KANEPACKAGE PHILIPPINE INC.

INVESTIGATION REPORT FORM (IRF)

Customer	SANYO DENKI PHILS INC.	Attention To	REXEL ALMARIO
Item Code	00949347-01	Department	PRODUCTION
Item Description	Print Specification	Date of Detection	250323
Job Order Number	JO25-M-00641-141	Section Detected	QA SCREENING

ILLUSTRATION OF THE PROBLEM

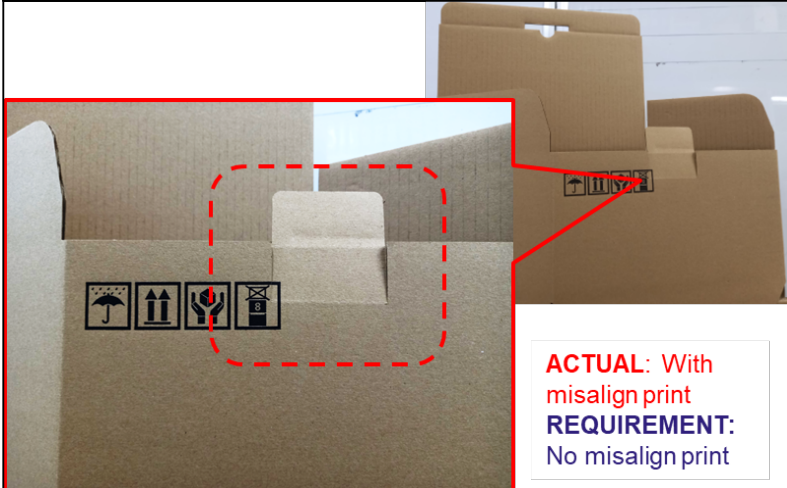
MISALIGN PRINT

Print tolerance ± 5 mm

Exceed specified print tolerance

WHY 1 : PRINT MOVED AGAINST THE REQUIRED DIMENSION r nFROM CREASING TO PRINT SHOULD BE 4MM BUT THE ACTUAL DIMENSION IS 9MM.

WHY 2 : THERE IS AN OCCURRENCE OF MOVEMENT OF MATERIAL DURING FEEDING PROCESS

WHY 3 : RANDOM OCCURRENCE OF UNEVEN SHEET SIZE.

WHY 1: GENERATE GUIDELINES WITH REGARDS RANDOM TAPPING FOR DIECUTTED ITEMS TO VERIFY THE CORRECTNESS OF BOARDS SIZE.
